Technical Review Committee

**CITY OF DELAND
THURSDAY MARCH 20, 2025 AT 1:30 P.M.
CITY OF DELAND TRC MEETING ROOM
DELAND, FLORIDA**

City of DeLand
SP24-198
DUPONT
WAREHOUSE

City of DeLand
SP25-007
HULLEY TOWER,
STETSON

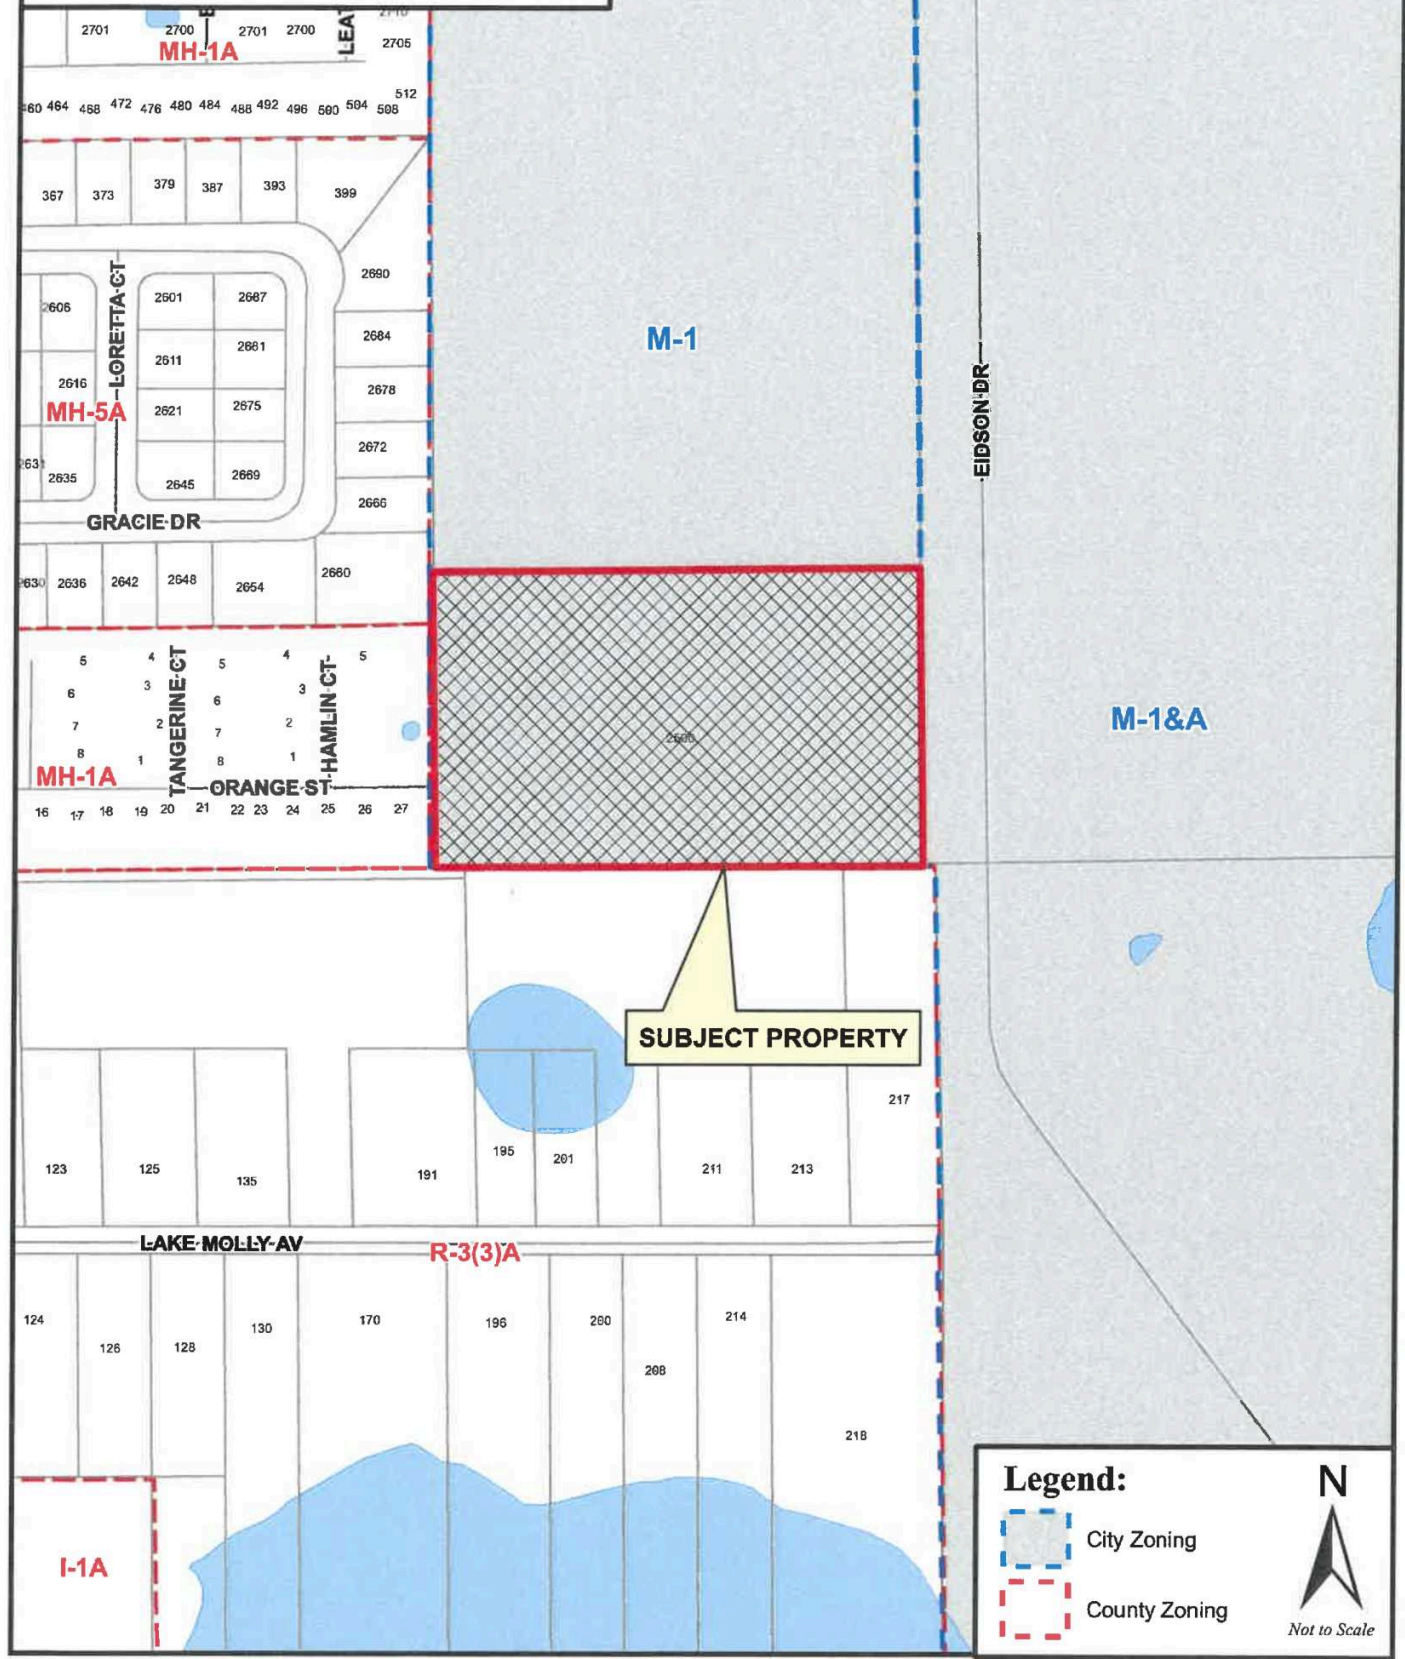
Discipline	Status	Details	Attached To	Created By	Last Updated By	Modifications Required
Stormwater Details						
Engineering	Draft	1. Structure MH-1 on this sheet identifies a 48" diameter, however the detail on Sheet C10 identifies 24" diameter. Please clarify.	C7	Steven Danskine	Steven Danskine	Yes

2. The response to the previous comment regarding the trench drain indicated that a detail was provided on Sheet C7. I am unable to locate this detail within the plans.

2. It is unclear how the 5" Bleed Down Orifice is intended to be constructed. The detail indicates that the Tee is to be inserted in the Weir, however on Sheet C8, it identifies that it may be a part of the Mitered End Section ST-15. The slope of the berm and weir are 4:1, however the detail identifies that the Tee should protrude 12" from the face of the Weir and/or MES. Since the Tee extends down 6", that means that the Tee would need to protrude at least 2', and even at that, the orifice would be buried in the dirt. The detail also indicates that the pipe connecting ST-15 and ST-16 is to be 5". To the best of my knowledge, 5" diameter pipe is not a standard option. Is this to be a specially manufactured item?				
Forestry	Draft	AR Label Please correct the number of AR's on the label. It should be 5.	LA3	Kit Dennis	Kit Dennis	Yes
Ligustrum Decipiens						
Forestry	Draft	Ligustrum Decipiens is invasive and should not be used in the landscape. Ligustrum lucidum is on our list of approved trees and can be used. To meet the minimum 8' height requirement, the spread should be 4' and the container size 65 gallon. That will equate to 3.5" caliper and result in 2.5" DBH per Ligustrum.	LA6	Kit Dennis	Kit Dennis	Yes

Plant Schedule						
Forestry	Not Accepted	In order for the proposed trees to meet the grade 1 standard, you will need to update the specs with the following information: AR - 4' spread, 45 gallon JV - 10' height, 3' spread LJ - 45 gallon MGD - 4' spread, 45 gallon MGL - 2' spread	LA1	Kit Dennis	Kit Dennis	Yes

Discipline	Status	Details	Attached To	Created By	Last Updated By	Modifications Required
Minimum Trees on Site Table						
1) Existing tree/palm inches preserved should be changed to 505" because trees 25 & 72 are being removed from the calculations due to being less than 6" DBH. 2) Proposed tree/palm inches provided on landscape plan- Your landscape plan provides 24" DBH of palms and 55" DBH of other trees. The total should be 79".						
Forestry	Not Accepted	Last comment from reviewer: The table will need to be adjusted once the project area has been worked out with Planning. In order to count the 2" - 5.9" Live Oaks, you will need to label the area as Natural Vegetation Retention/Tree Protection Area. Tree #72 would not be counted because it is not a species that is on the List of Permitted Shrubs and Trees for Landscaping and Tree Protection. Last response: 1.The project limits have changed from 6 acres to 11.81 acres. See revised Tree Protection and Landscape sheets for revised calculations on sheet TP2. 2.The project limits have changed from 6 acres to 11.81 acres. See revised Tree Protection and Landscape sheets for revised calculations on sheet TP2.	TP1	Kit Dennis	Kit Dennis	Yes

15% "Natural Preservation" Table						
1) Change all references of "natural preservation" to "tree protection area" to be consistent with the language in our code. 2) Total Site Area - Is the site area shown, correct? Property Appraisers website shows it as 6.03 AC. 3) Replanted Preservation Area - There is not any area in the landscape plan that is labeled as Tree Protection Area and shows planting. Where is this planted protection area located? Please show it as Tree Protection Area on the plan sheets.						
Forestry	Not Accepted	Last comment from reviewer: Tree Protection Areas are different than Natural Vegetation Retention Areas. The two can overlap, but you must label them. The table should reference the Tree Protection Area. Last response: 1.he project limits have changed from 6 acres to 11.81 acres. See revised Tree Protection and Landscape sheets for revised calculations on sheet TP2. 2.he project limits have changed from 6 acres to 11.81 acres. See revised Tree Protection and Landscape sheets for revised calculations on sheet TP2. 3.Due to the project limit change, there will be no need for a replanted preservation area.	TP1	Kit Dennis	Kit Dennis	Yes

DBH Preserved						
Forestry	Not Accepted	After removing trees 25 & 72 from the calculations, the DBH preserved should show 505". Last comment from reviewer: 2" - 5.9" Live Oaks can be counted, but you will need to label the area as Natural Vegetation Retention/Tree Protection Area. Tree #72 would not be counted because it is not a species that is on the List of Permitted Shrubs and Trees for Landscaping and Tree Protection. Last response: The project limits have changed from 6 acres to 11.81 acres. See	TP1	Kit Dennis	Kit Dennis	Yes

Forestry	Not Accepted	Last comment from reviewer: Irrigation plan has not been provided at this time.	C1	Kit Dennis	Kit Dennis	Yes
Last response: An irrigation plan shall be provided upon final approval.						
Combined Preliminary/Final Plat						
A shared stormwater pond must be in a tract with "purpose, ownership and maintenance" clearly defined. More than 2 lots (tract would count as a lot) requires a preliminary and final plat submittal review and approval prior to completion of the site plan.						
Planning	Draft			Emily Ragusa	Emily Ragusa	Yes
Parking						
Parking calculations need to be based on this floorplan to include warehouse, office, & manufacturing.						
Planning	Draft		F1	Emily Ragusa	Emily Ragusa	Yes
TPA						
15 percent Tree Protection Area must be based on the 6.03acres, not the 11.81acres.						
Planning	Draft		TP1	Emily Ragusa	Emily Ragusa	Yes
Plant Schedule						
Provide the plant schedule on all landscape sheets

Planning	Draft		LA6	Emily Ragusa	Emily Ragusa	Yes
Landscape Buffer table						
Add headers for which column is required and which is proposed						
Planning	Draft		LA1	Emily Ragusa	Emily Ragusa	Yes
C11 and C12						
Sheets C11 and C12 are not labeled in order, please revise.						
Planning	Draft			Emily Ragusa	Emily Ragusa	Yes
Pond						
Revise sheet to reflect the shape of pond as shown on other sheets						
Planning	Draft		ES101A	Emily Ragusa	Emily Ragusa	Yes

Discipline	Status	Details	Attached To	Created By	Last Updated By	Modifications Required
Planning	Not Accepted	True South Elevation Consider painting the internal pillars the same color as others - SW6538 to break up the blank wall (LDR Sec. 33-94.03(b)(4)(h))	A-202	Emily Ragusa	Emily Ragusa	Yes
		Last comment from reviewer: Revised elevations need to be submitted				
		Last response: The internal pillars will be the same color as others.				
		Blank Walls (rear - true west) Blank wall areas shall not exceed 20 feet in vertical direction or 20 feet in horizontal direction of any building facade. Consider adding additional architectural elements such as blue vertical pillars similar to other side facades (true east example) (LDR Sec. 33-94.03(b)(4)(h))				
Planning	Not Accepted	Last comment from reviewer: Revised elevations need to be submitted	A-201	Emily Ragusa	Emily Ragusa	Yes
		Last response: This was incorporated into the final elevations by adding pilasters

Retaining wall Provide dimensional elevations of the retaining wall from top to bottom in 5-ft increments.				
		Last comment from reviewer: Provide the structural plans				
Planning	Not Accepted	Last response: Please see Sheet C7 for the high point (HP) and low point (LP) of the retaining wall. The wall never exceeds 4 feet.	C6	Emily Ragusa	Emily Ragusa	Yes
		Mechanical Equipment Building mechanical equipment, service, delivery, and work areas, shall be visually screened from pedestrian areas and from public view. Revise plans to show the roof top mechanical equipment as dashed lines behind the screen wall on all facades and add a note of detailing the material and dimensions for the screening. (LDR Sec. 33-94.03 (a)(4))				
		Last comment from reviewer: Revised elevations need to be submitted				
		Last response: This was incorporated into the final elevations. Screening will be attached to RTUs.

Planning	Not Accepted	Impervious Surface Max impervious surface for M-1 zoning district is 70%.	A-201	Emily Ragusa	Emily Ragusa	Yes
		Last comment from reviewer: Project area is unclear. The impervious surface percentage needs to be based on the project area (6.03acres). The proposed lot lines needs to be clear.				
		Last response: The future impervious surface has been lowered to 70% for each lot, please see stormwater report.

Discipline	Status	Details	Attached To	Created By	Last Updated By	Modifications Required
Planning	Not Accepted	Landscape Buffer (True East) Eldson is a local road - buffer must be at least a type "B" (LDR Sec. 33-92.02 (b))				
		Last comment from reviewer: Show the dimensions of the buffer		Emily Ragusa	Emily Ragusa	Yes
		Last response: The landscape buffer for Edison has been changed to reflect a type 'B' buffer. See LA1 & LA2.	LA2			
Planning	Not Accepted	Landscape Buffer (True West & true South) Specify the buffer standard proposed. Because this is abutting residential use, the buffer standard of "D" shall be used and in addition to the specific requirements for Buffer Standards "D" contained in Table 33-92.02(b), the buffer must also include a 100 percent opaque screen (fence or wall) along the rear or side lot line. The screen shall be a minimum of six feet high and a maximum of eight feet high. The screen shall be located no closer than ten feet to the abutting property line and landscape materials shall be located between the screen and the abutting property line. (LDR Sec. 33-92.02 (b))

Last comment from reviewer: Provide the fence detail, the C5 sheet reference does not include the fence detail.	C6	Emily Ragusa	Emily Ragusa	Yes
		Last response: The West & South buffer requirements have been revised to match type 'D' buffer. See sheet LA1 for buffer requirements and provided. A fence has been added to the pans as stated above.				
Planning	Not Accepted	Site Data Table Provide the site data table/parking calculations on the coversheet on the overall site plan				
		Last comment from reviewer: Site Data table and parking calculations are not on C6	C1	Emily Ragusa	Emily Ragusa	Yes
		Last response: Please see Sheet C6.				
Planning	Not Accepted	Signage Is signage proposed? If so, provide the location on the site plan (LDR Sec. 33-132.10(a)(2)(f))				
		Last comment from reviewer: Sheet C6 does not include signage callout. Provide the updated final elevations for review.		Emily Ragusa	Emily Ragusa	Yes

Last response: Monument sign proposed, see Sheet C6 for call out. Provisions for building/ wall mounted signage was incorporated into the final elevations. Signage will be provided by owner/ contractor.				
Planning	Not Accepted	Project Area The plan shows only parcel 602800000052, which per the survey is +/- 6.03 AC. The cover sheet states 16.109 AC. Please clarify the new lot configuration from the minor subdivision (MS24-139) and verify that all calculations are based off of the new lot. If drainage is to be off-site, easements shall be recorded and shown on the site plan.	C1	Emily Ragusa	Emily Ragusa	Yes

Discipline	Status	Details	Attached To	Created By	Last Updated By	Modifications Required
Planning	Not Accepted	Last comment from reviewer: Clearly define the project area and the total acreage and square footage. Per Volusia County Property Appraiser, Parcel ID# 602800000052 is 6.07 acres of "vacant commercial", 602800000050 is 8.29 acres of "vacant commercial", 22.56acre of "waste land" and the provided survey states 6.03acres. All calculations need to be based on the 6.03ac of this project site, each lot must meet all regulations on their own. If you're proposing to do a shared stormwater system, then the stormwater pond needs to be placed into a tract and a preliminary and final plat will be required.				
		Last response: The proposed stormwater will treat the entire 16.109 acres, this includes an assumed 70% impervious for the 2 vacant lots and proposed impervious for the 6.03 acre lot.

Project Description Clarify the total proposed square footage - Plans state 38,110 SF, and project description in Accela states 41,800 SF.				
		C1	Emily Ragusa	Emily Ragusa	Yes	
Planning	Not Accepted	Parking Table Ensure the parking table reflects the same information provided in the parking memo. Memo states 32 spaces required, but plan states 29.				
		Last comment from reviewer: Parking memo and table do not match. The parking calculations need to be broken down and shown in a table by each use within the building and the required number of spaces for each use, such as warehouse, manufacturing/workshop, office, etc. LDR Sec. 33-91.03.				
		C1	Emily Ragusa	Emily Ragusa	Yes	
		Last response: The parking table shown on Sheet C1 has been updated to match the parking memo				
Utilities	Open	Fire Hydrant FH is shown coming off of the 2" water line instead of 6" fire line.				
		C9	Jim Ailes	Jim Ailes	Yes

Utilities	Not Accepted	Irrigation Show how site will be irrigated. Reclaim line is north on Edison by Davita Way intersection. A 12" reclaim line is available.				
		Last comment from reviewer: Design for cistern still pending.				
		C1	Jim Ailes	Jim Ailes	Yes	
		Last response: A cistern will be utilized for irrigation and the design is being finalized and forwarded upon completion.

Discipline	Status	Details	Attached To	Created By	Last Updated By	Modifications Required
Sewer Cleanout						
Utilities	Not Accepted	Please show a sewer clean out by right of way.				
		Last comment from reviewer: No clean out shown.	C9	Scott Zender	Jim Ailes	Yes
		Last response: Please see Sheet C9 for location of added sewer clean out.				
Potable Line						
Utilities	Not Accepted	City requires that the potable service line needs to be tapped off of water main and not connected to the fire line.				
		Last comment from reviewer: Looks same as before on sheet C9.	C9	Scott Zender	Jim Ailes	Yes
		Last response: Potable service line has been updated to tap directly to the water main, see Sheet C9.

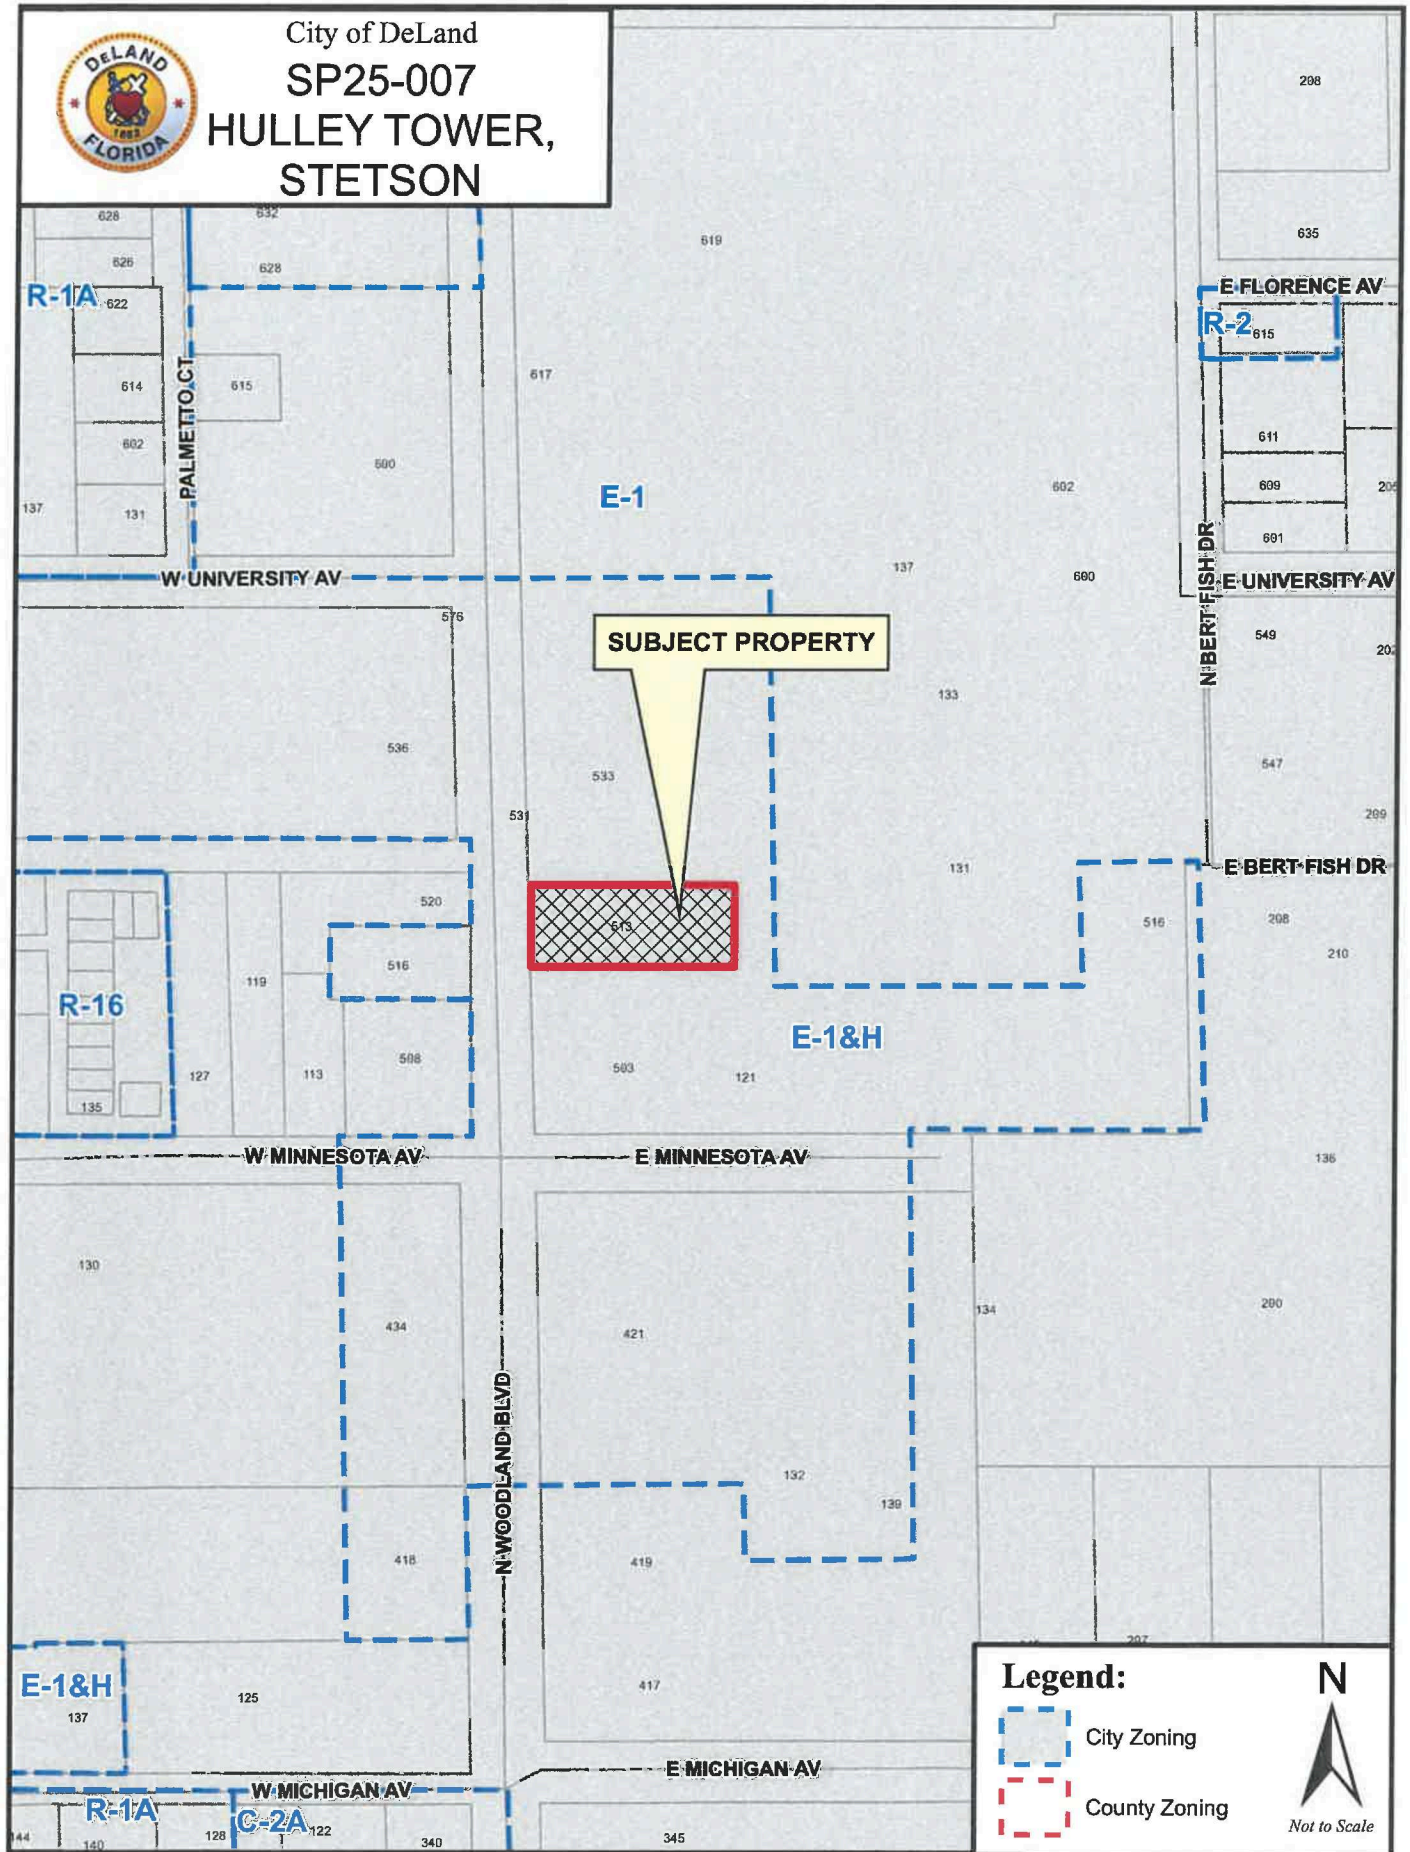
Discipline	Status	Details	Attached To	Created By	Last Updated By	Modifications Required
Tree Barricade Details						
Forestry	Draft	You can remove the Historic Tree Barricade detail as we will not require a historic tree barricade around the trees due the magnitude of activity that will be occurring in the areas. Please update the Typ City Tree Barricade detail with the most recent version, dated January 11, 2024. It is available on our website.	TP1	Kit Dennis	Kit Dennis	Yes
Replacement Required						
Forestry	Draft	Your chart shows 152" DBH of non-specimen protected tree removals. The "Total DBH Replacement Required" should be 51".	TP2	Kit Dennis	Kit Dennis	Yes
Tree Worksheets						
Completed Tree Worksheets are needed. Please also provide a spreadsheet that identifies the species and DBH of the trees that are on the project site. Identify which trees are to remain and which are being removed. Tree replacement calculations cannot be calculated until the information is provided.

Forestry	Not Accepted	Last comment from reviewer: The information in your Specimen - Historic - Protected Tree Calculations table does not match what is provided in the worksheets. Your table shows 152" DBH of non-specimen trees, but the Tree Replacement Worksheet shows 132". At 152" DBH removed, the replacement would be 51". The Minimum Tree Coverage Worksheet shows retention of 346" specimen trees, and 449" of non-specimen trees. The table shows 415" of specimen, and 380" of non-specimen trees being retained. Please correct the worksheets.		Kit Dennis	Kit Dennis	Yes
Last response: The worksheets have been completed as well as a spreadsheet for the existing species and their related sizes and classifications.						
Root Excavation						
Forestry	Not Accepted	I recommend having an ISA Certified Arborist perform root excavation on all of the historic trees in order to identify the critical roots. The locations of the roots may alter your plan.	LA1	Kit Dennis	Kit Dennis	Yes

Last comment from reviewer: City staff from Forestry will need to approve the measures that are being taken to minimize damage to the historic trees root systems.						
Last response: Stetson will have their onsite Staff available for consultation throughout

Historic Tree Barricade Locations and Detail Add the City's historic tree barricade detail to the plan. You will need to show the locations of the protected trees barricades, and the historic trees barricades.						
Forestry	Not Accepted	Last comment from reviewer: We will not require historic tree barricades to be installed around each historic tree. We will require that a typical tree barricade be installed around each tree that is to be preserved. This is to prevent activities, or storage of materials in the area required to protect the trees. Last response: The tree barricade details have been added to sheet TP1. The construction fence shall encompass the entire site ensuring the best-case scenario for tree root protection.	TP1	Kit Dennis	Kit Dennis	Yes
Historic Tree Protection There are six historic trees on this site. One and a half times the drip line must be protected. No construction activities are permitted within the protection area without stating what measures will be taken to ensure the trees survival. Your plan includes several paver walkways with concrete curbing, a "named plaza" paver area, paver seating circle, fireplace, concrete sidewalks, and lighting. Please explain what measures will be taken to prevent damage to the tree's root systems.

Forestry	Not Accepted	Last comment from reviewer: City staff from Forestry will need to approve the measures that are being taken to minimize damage to the historic trees root systems. Last response: Stetson will have their onsite Staff available for consultation throughout the project and will provide direction to the contractor as needed. Williams Company has extensive experience of constructing projects on the Campus and is fully aware of and capable of working around the historic trees. As suggested, we've added notes to the plan that no roots over 2" are cut without review and approval of Stetson. The Contractor will also provide additional input and regular updates to the Stetson management team on their means and methods as the project progresses.	TP1	Kit Dennis	Kit Dennis	Yes

Discipline	Status	Details	Attached To	Created By	Last Updated By	Modifications Required
Planning	Not Accepted	Photometric Plan Define the proposed project area, and provide an updated photometric plan. Ensure that illumination from any light source onto adjacent properties or into the public right-of-way shall not exceed 0.5 foot-candles Per LDR Sec. 33-94.03(g)(2) Last comment from reviewer: An updated photometric plan will need to be submitted Last response: The pedestrian pathway lighting is currently being evaluated and will be provided. We will ensure that illumination from any light source onto adjacent properties or into the public right-of-way shall not exceed 0.5 foot-candles.	1	Emily Ragusa	Emily Ragusa	Yes
		Uplight/spot luminary Provide the foot candles details Per LDR Sec. 33-94.03(g)(9)(a) Last comment from reviewer: Provide a note on the plan that states that up lighting will not exceed the tree tops Last response: Foot candles cannot be calculated for a tree canopy for the uplighting fixtures. The illumination from up-light fixtures shall not exceed the roof line (treetop in this case). Code only references building surfaces, not vegetation.	HA1	Emily Ragusa	Emily Ragusa	Yes

Irrigation Plan Provide an irrigation plan of the project area Last comment from reviewer: Provide a preliminary irrigation plan in addition to the as-built irrigation plan Last response: Irrigation will be design-built by the landscape contractor. Areas will be hydro-zoned based on the water needs of each plant type. An ass-built irrigation plan will be submitted upon substantial completion.	LA1	Emily Ragusa	Emily Ragusa	Yes
Planning	Not Accepted	Campus-wide Parking Seven (7) visitor parking spaces are shown as removal. The campus-wide parking capacity will need to be updated and resubmitted showing where these spaces will be relocated on campus. Last comment from reviewer: Revise the summary page to show how the parking is being subtracted. Suggest adding an additional column notating the difference (-3) and a bullet/detail on the page stating the reason for the subtraction or relocation (example: Hulley Tower reconstruction SP25-007). Last response: Please see the revised summary page documenting the current parking status after losing three (3) parking spaces.	C4	Emily Ragusa	Emily Ragusa	Yes
